Dear Editor,

Response to Reviewer #1

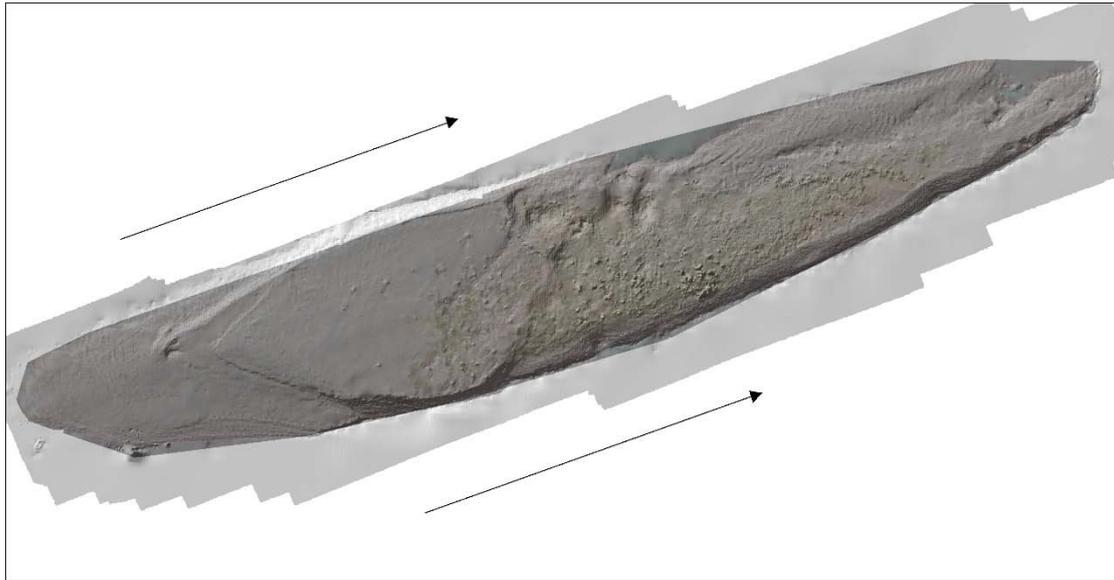
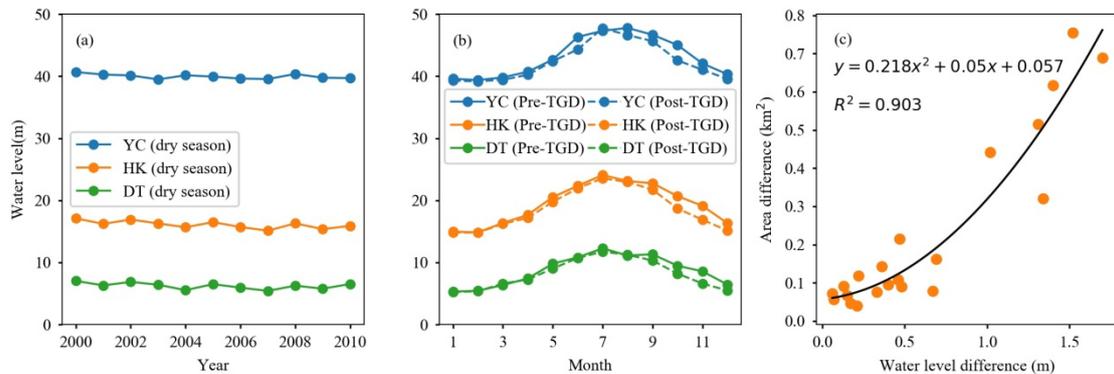
(2) P5L25. Banks of MCBs may have quite a small slope and MCBs area could then be very sensitive to water level. Do the authors have characterized this sensitivity?

Response: Thanks for the question. According to our *in situ* observation, banks around the tail parts of MCBs (downstream parts) often present gentle slopes, while banks around the head parts of MCBs (upstream parts) are often in steep slopes due to the general deposition (at tail) and erosion (at head) pattern (Fig. R1). We agree that the MCBs areas are sensitive to water levels. That is why we have carefully considered this sensitivity by minimizing water level variations through selecting images only acquired in dry season as illustrated in Fig. 2. Following the suggestion, we have analyzed the sensitivity of the water level change on the MCBs areas and inserted the result into Fig. 2 (Fig. 2c). It is spotted that 0.5 m change of water level could cause about 0.1 km^2 change of MCBs' area.

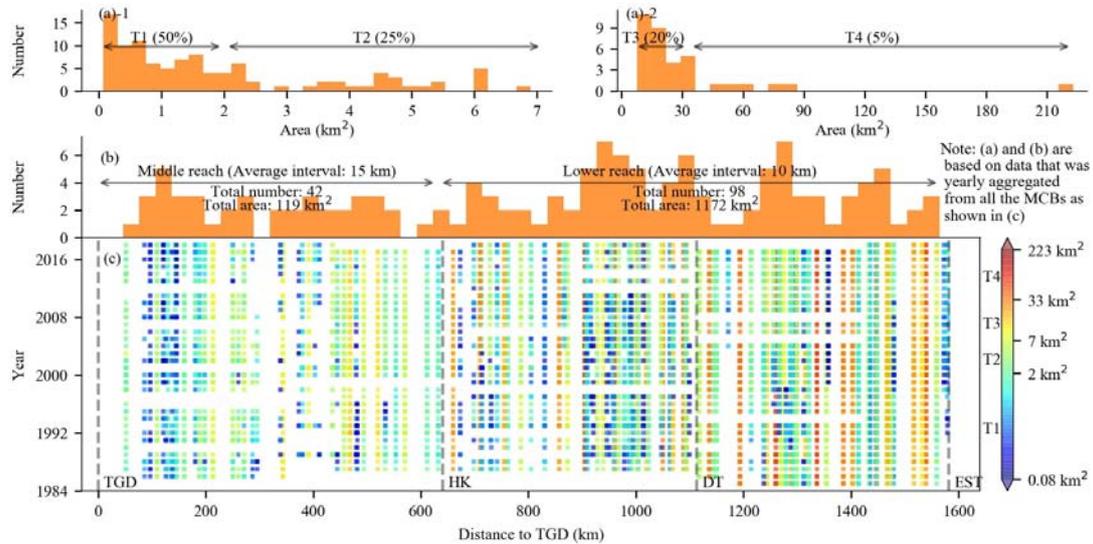
(7) P10L4. The authors mention the density of MCBs in the text, whereas they use the term “frequency” in Fig. 5. Please be consistent.

(22) Fig 5. Please define frequency (or density to be consistent with the text) in this context. Also, does each dot in Fig 5c represent a single MCB? If yes, this should be said.

Response: The term “Frequency” was changed to “Number” in Fig. 5.

Response: Fig. 5 has been modified as suggested. Each dot in Fig 5c represents a single MCB and the caption has been corrected.

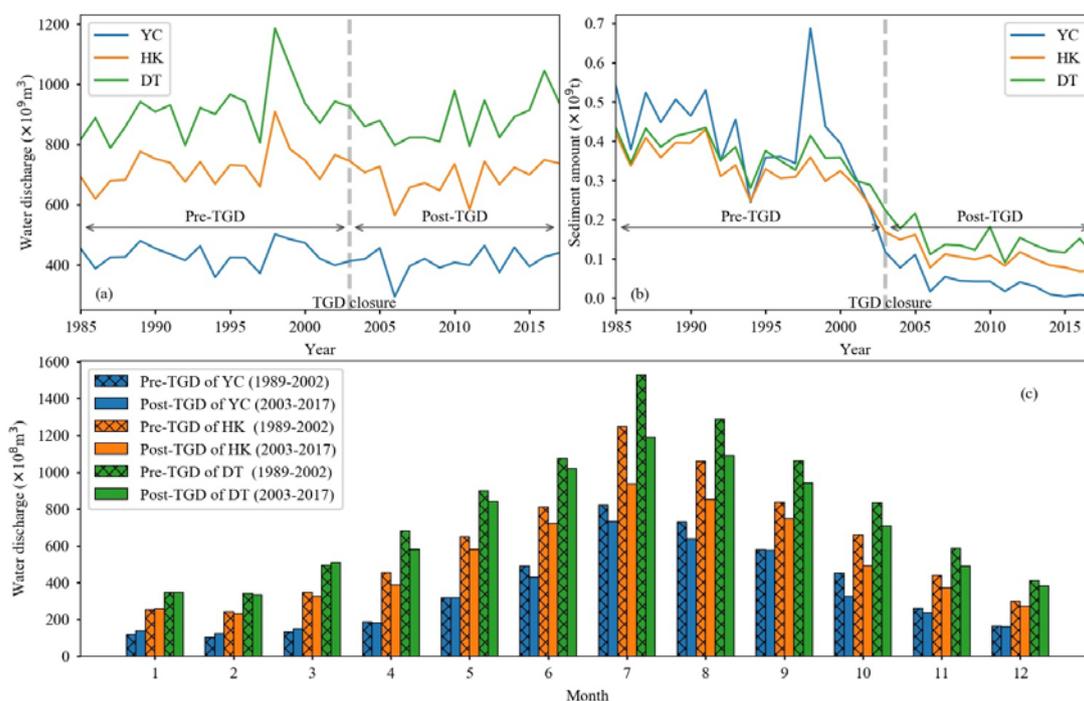
(15) P13L4-5. Could the authors add a figure showing seasonal averages over pre- and post-TGD closure periods?

(16) P13L10-15. An expected impact of TGD operations is the flood peak reduction. Could the authors show a graph depicting the evolution of extreme discharges before and after the TGD closure?

Response: Thanks for the good suggestion. The figure showing seasonal averages pre- and post-TGD was added (Fig. 13c).

Response: Thanks for the suggestion. The new Fig. 13c (please see the response to the last comment) was added to show the reduction of peak water discharge in flood season after the TGD closure.

Figure 11: CV-indicated temporal stability of all individual MCBs changed with their sizes (indicated by logarithmized area) in different periods (overall, pre-TGD, and post-TGD).

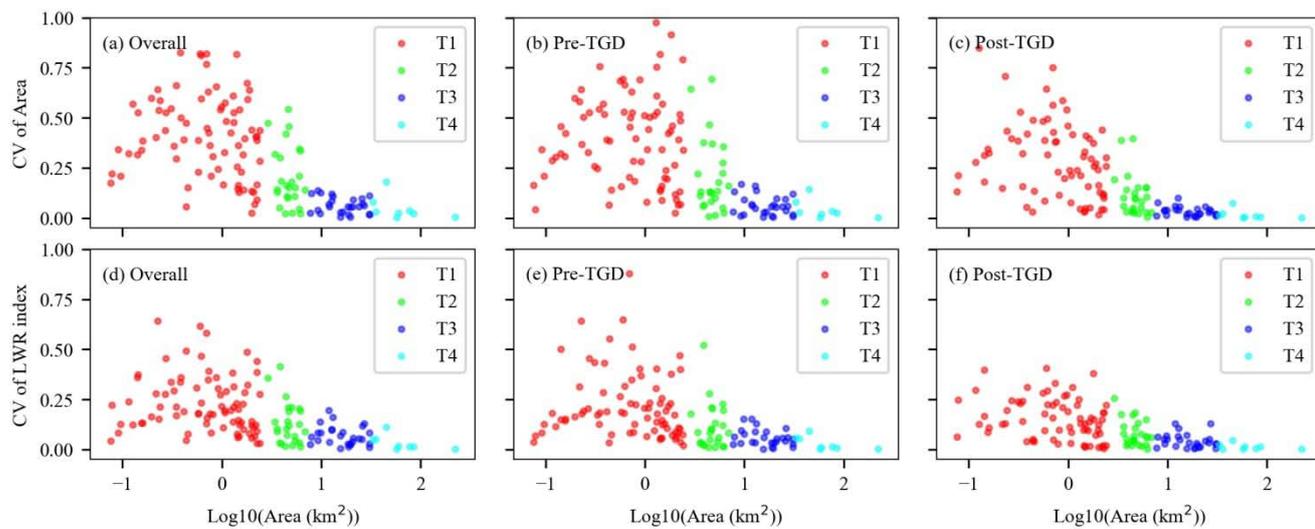
(23) Fig 11. I would suggest to keep same y-axis bounds on each graph for a better comparison (at least for each line).

Response: Revised as suggested.
